**TSG-RAN Meeting #13
Beijing, China, 18 - 21 September 2001**

RP-010538

Title: Agreed CRs (Release '99 and Rel-4 category A) to TS 25.303

Source: TSG-RAN WG2

Figure 34: Combined Cell/URA Update and SRNS relocation (lossless radio bearers)

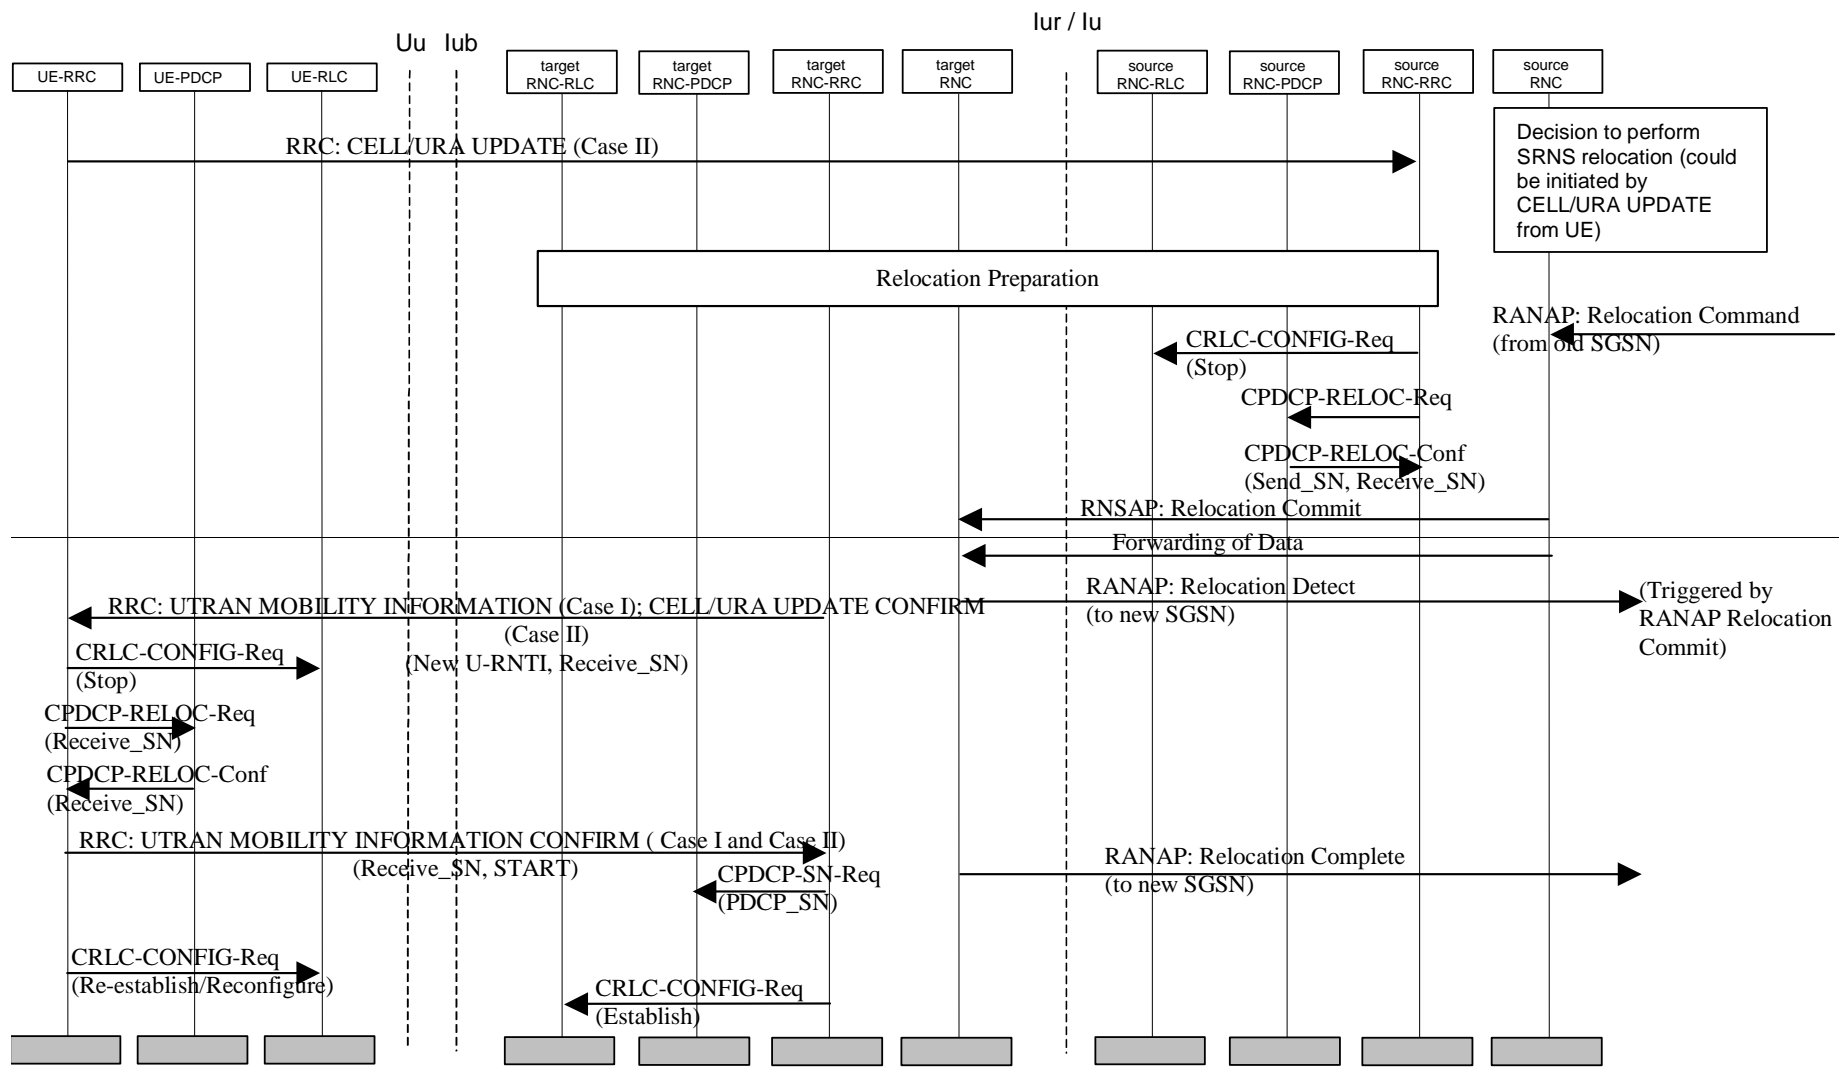
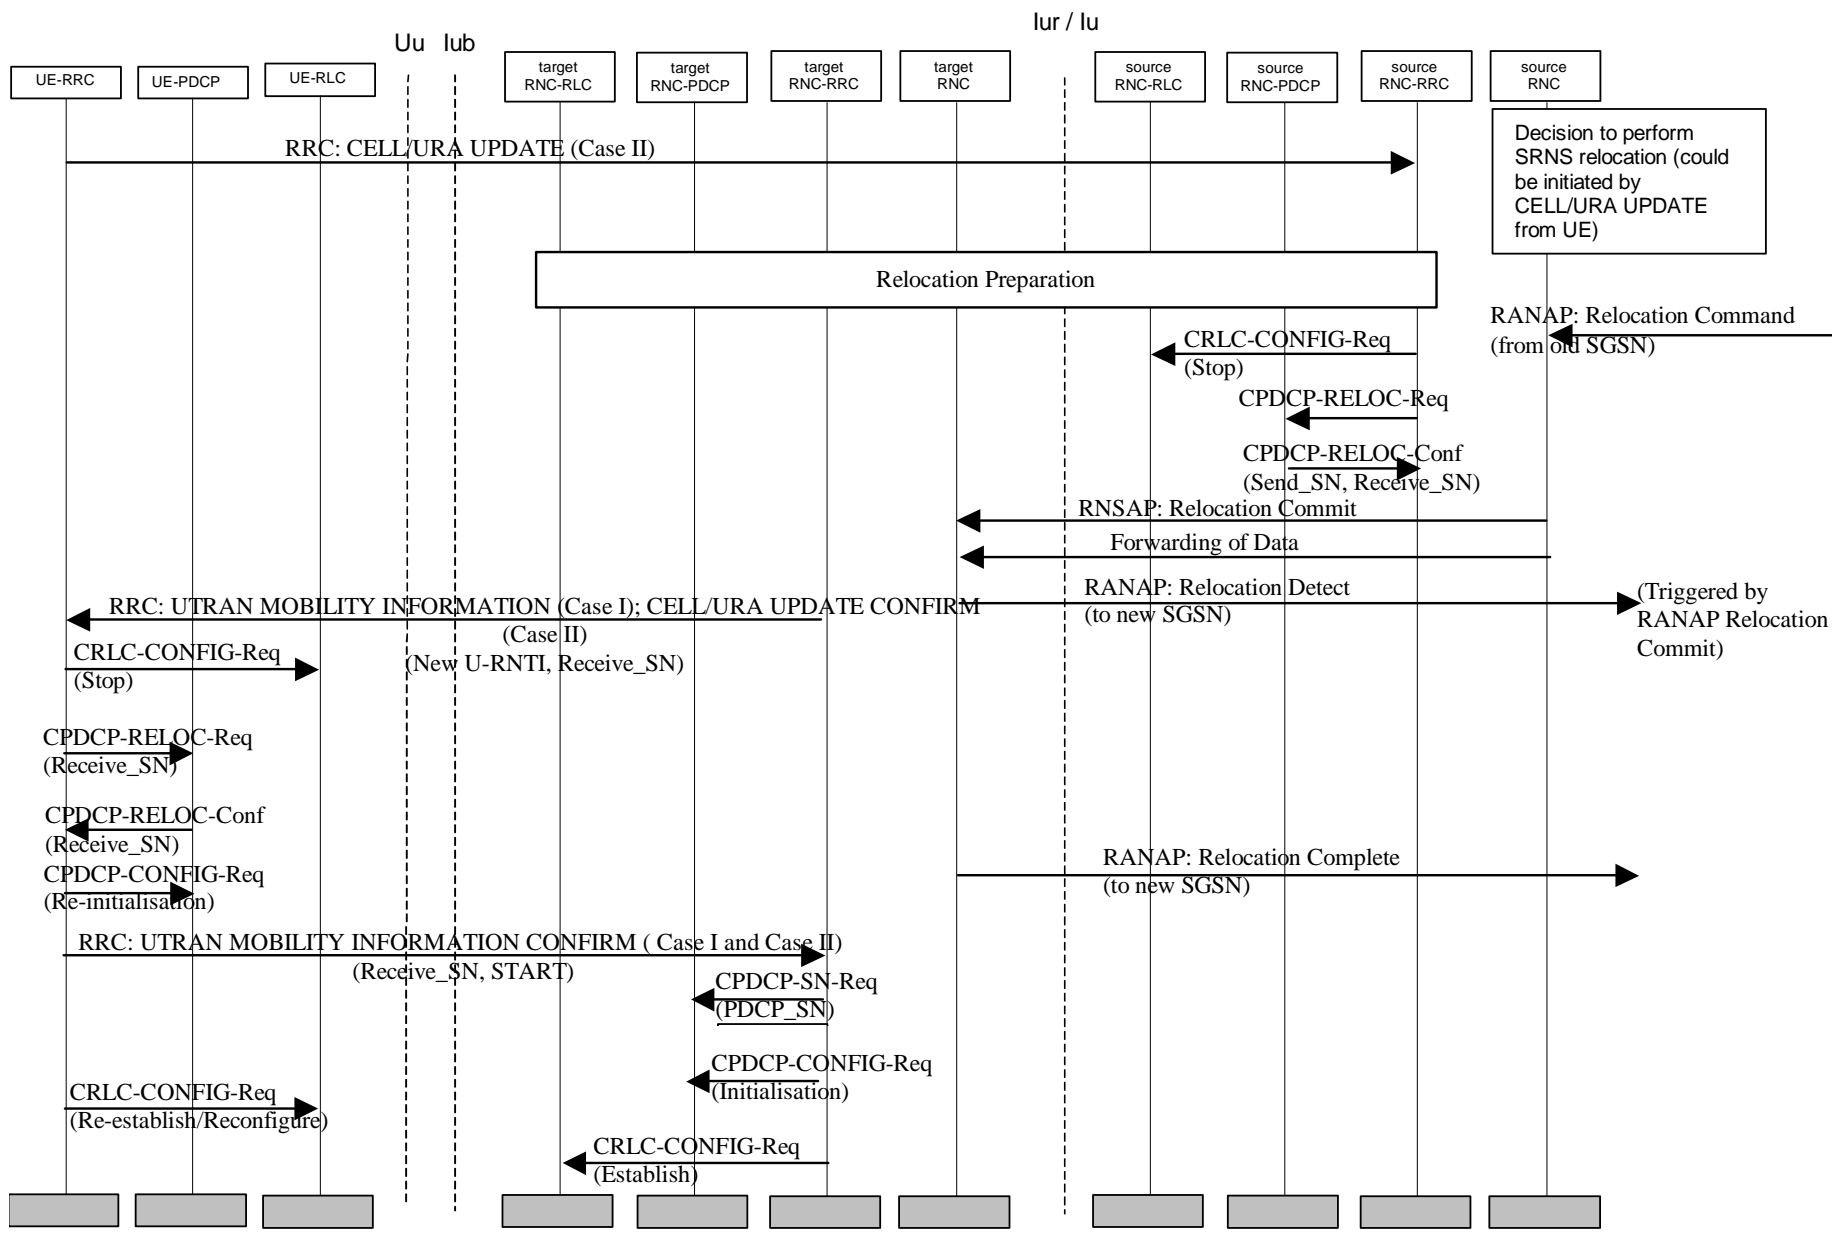
Reason for change:	⌘ Shadow CR to CR 050 on Rel-99. As described in Tdoc R2-010896 presented during RAN WG2#20, currently, the handling of PDCP Header Compression protocol during SRNS relocation is not described in the TS.
Summary of change:	⌘ A new parameter in the CPDCP-CONFIG primitive between PDCP and upper layers is proposed to be has been defined in a companion draft CR to 25.323 and is used to reinitialise the entire context at the decompressor during SRNS relocation when Header compression is used. This is applicable for lossless, lossy and seamless radio bearers.
Consequences if not approved:	⌘ Description of header compression reinitialisation during SRNS relocation will not be complete.

The target RNC then sends a UTRAN MOBILITY INFORMATION (Case I) or a CELL/URA UPDATE CONFIRM (Case II); which configures the UE with the new U-RNTI and indicates the uplink receive PDCP sequence number for each radio bearer configured to support lossless SRNS relocation. The UE compares the uplink receive PDCP sequence number with the UE uplink send PDCP sequence number. If this confirms PDCP SDUs successfully transferred before the start of relocation i.e. already received by the source RNC then these are discarded by the UE. The UE reinitialises the PDCP header compression entities of the radio bearers configured to use a header compression protocol [7].

Figure 35: Combined Hard Handover and SRNS relocation (lossless radio bearers)

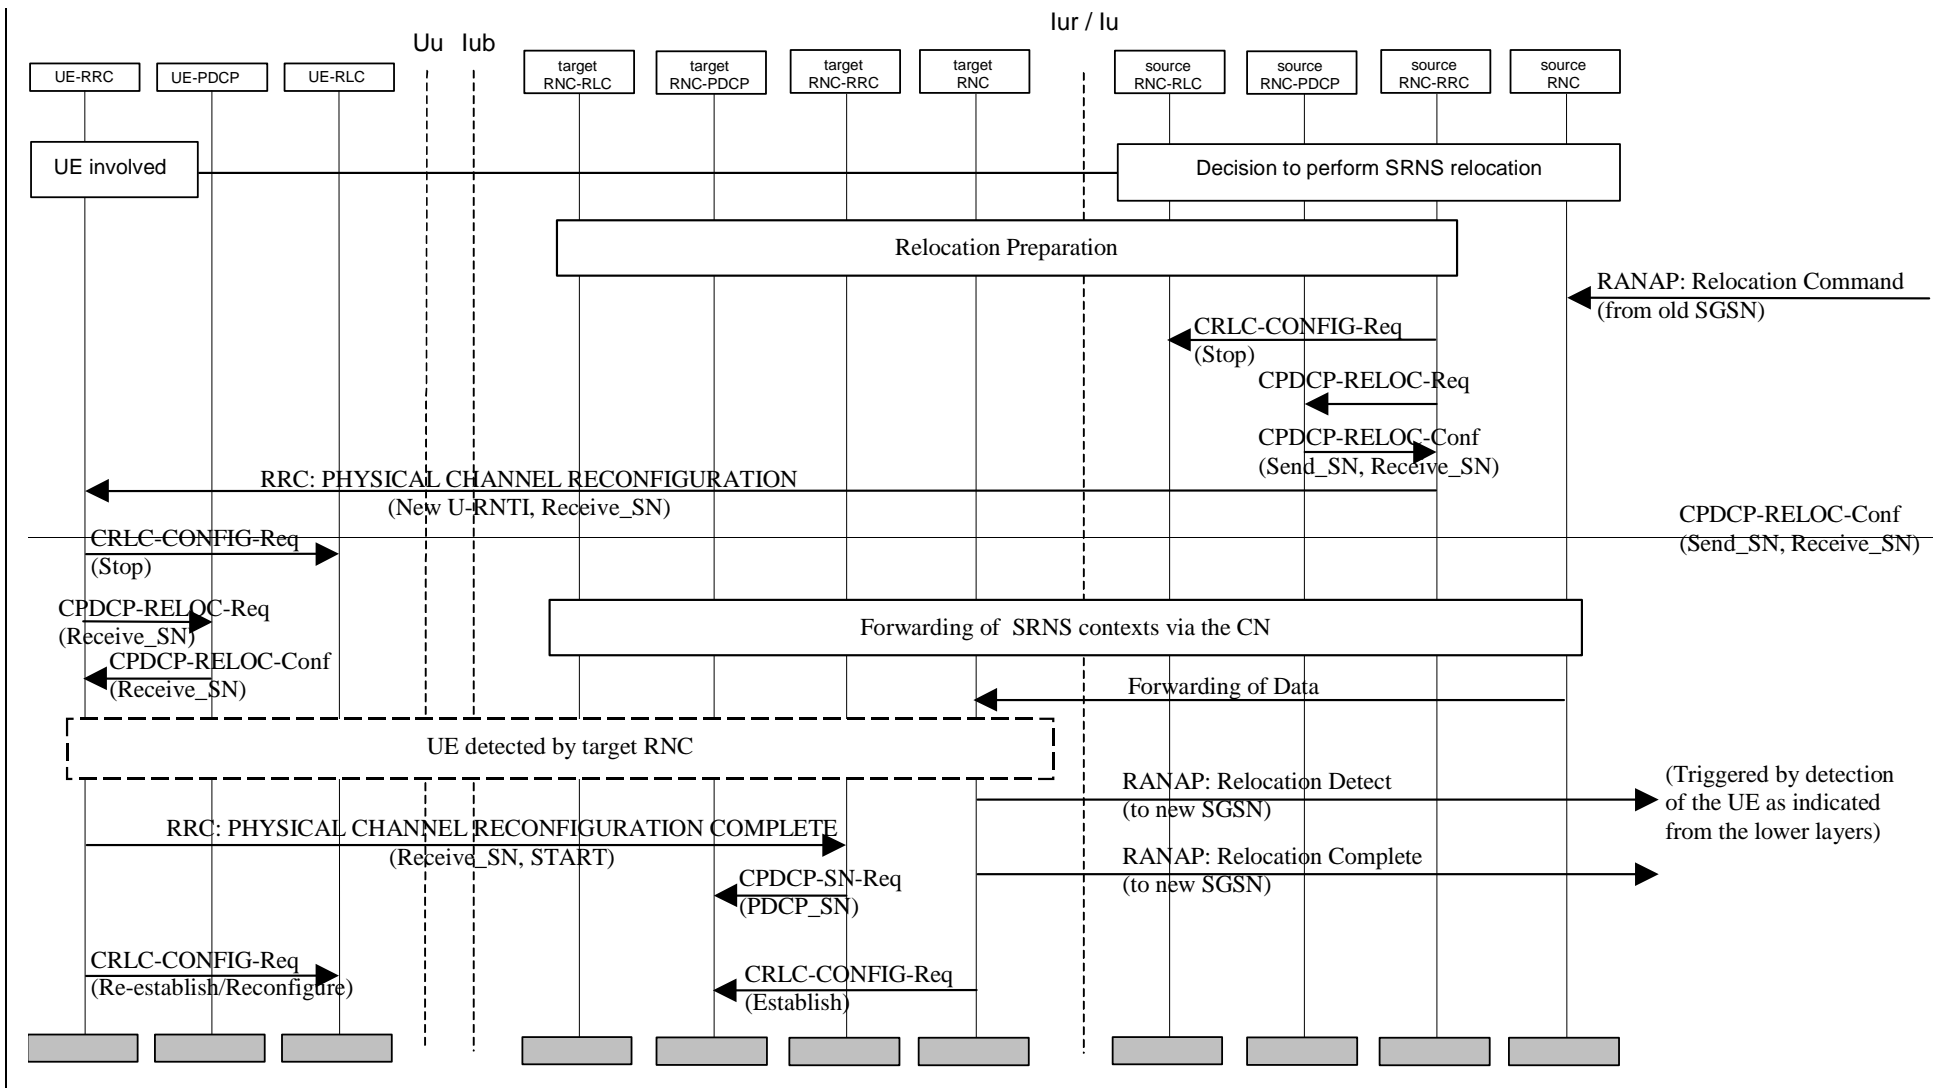
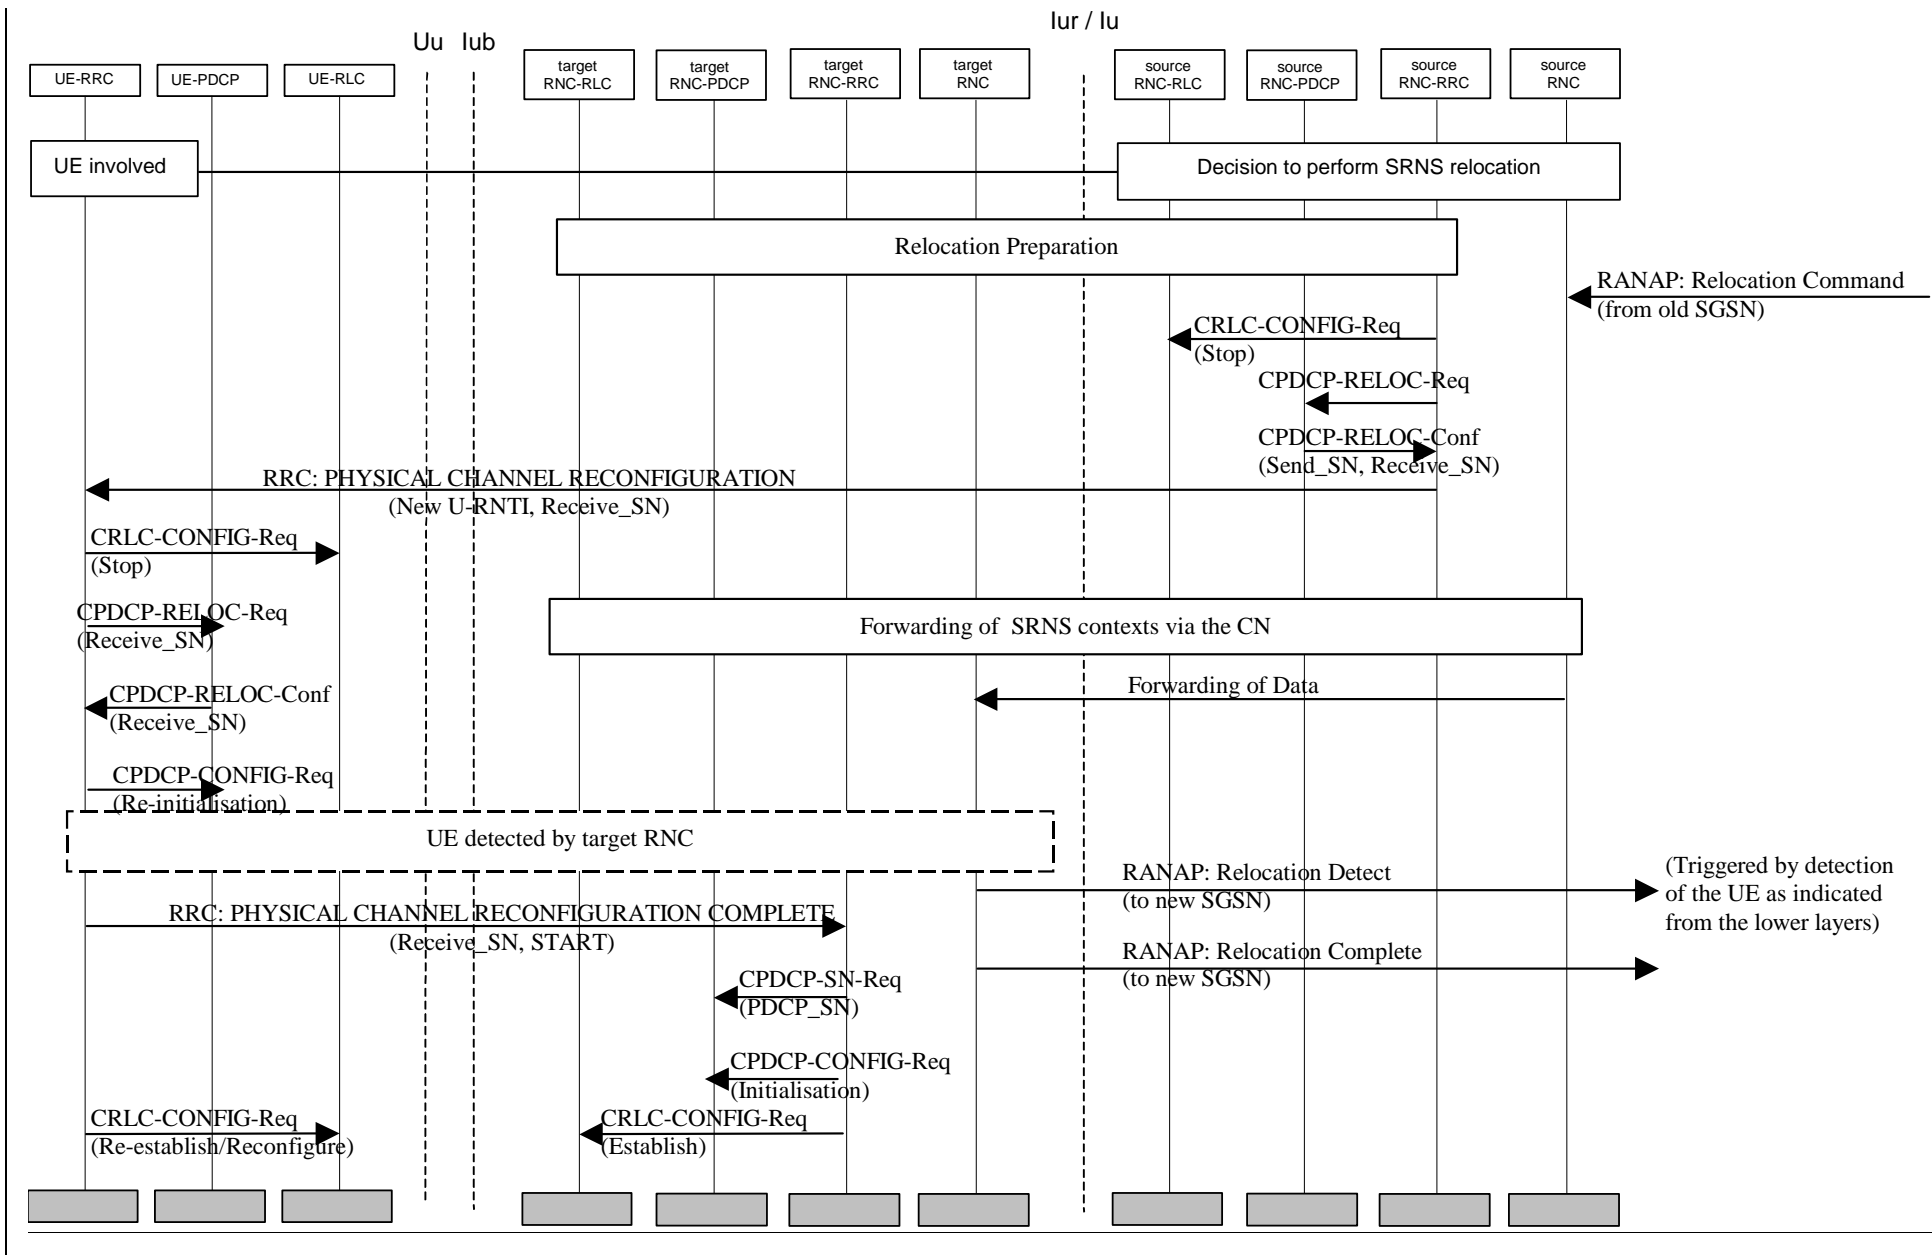
The Target RNC to Source RNC Transparent Container includes the RRC message (e.g. PHYSICAL CHANNEL RECONFIGURATION) for hard handover. Upon reception of the RANAP Relocation Command, the source RNC triggers the execution of the relocation of SRNS by sending the RRC message to the UE. This message includes the new U-RNTI and the uplink receive PDCP sequence number for each radio bearer configured to support lossless SRNS relocation. The UE compares the uplink receive PDCP sequence number with the uplink send PDCP sequence number. If this confirms PDCP SDUs successfully transferred before the start of relocation i.e. already received by the source RNC then these are discarded by the UE. The UE reinitialises the PDCP header compression entities of the radio bearers configured to use a header compression protocol [7].

Figure 30: Radio Link Addition

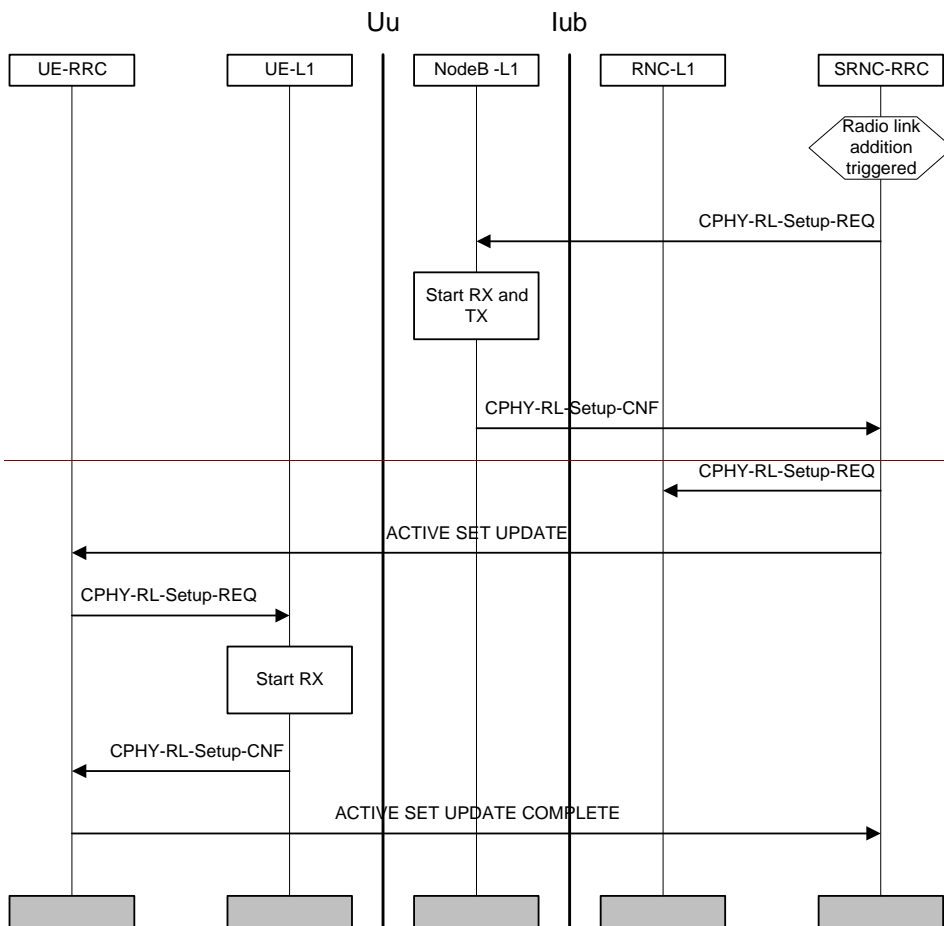
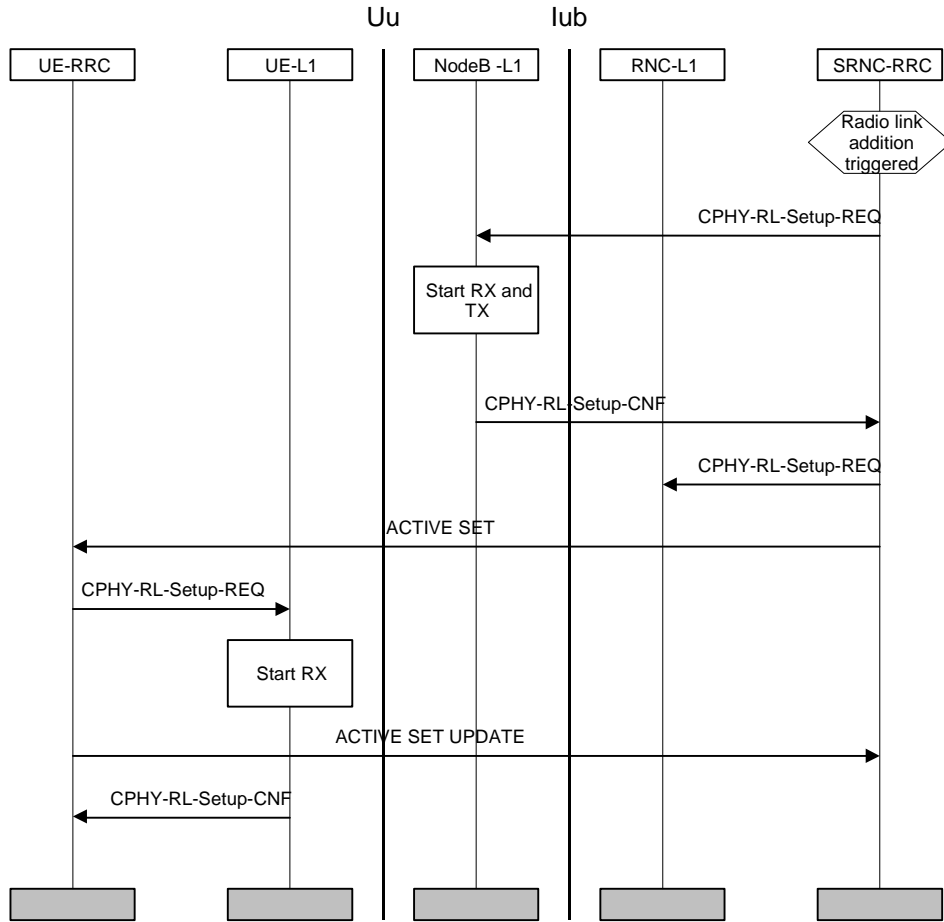
Reason for change:	⌘ It is stated in section 8.3.4.3 of 25.331 that after receiving an ACTIVE SET UPDATE message the UE shall - 'transmit an ACTIVE SET UPDATE COMPLETE message on the uplink DCCH using AM RLC without waiting for the Physical Layer synchronization;'		
	However in section 6.4.4 of 25.303 it states the UE shall wait for indication from the physical layer before sending the ACTIVE SET UPDATE COMPLETE message. This is wrong and is corrected.		
	Isolated impact analysis:		
	This correction is to a function where the specification was not sufficiently explicit. This would not affect implementations behaving like indicated in the CR, but would affect implementations supporting the corrected functionality		
Summary of change:	⌘ The UE does not need to await indication of layer 1 synchronisation before sending the ACTIVE SET UPDATE COMPLETE message to the UTRAN.		
Consequences if not approved:	⌘ Increased delay in performing Active Set Update procedure

~~After confirmation from the physical layer in~~The UE shall send an ACTIVE SET UPDATE COMPLETE message is sent to the RNC-RRC without waiting for an indication of synchronisation from the UE physical layer.
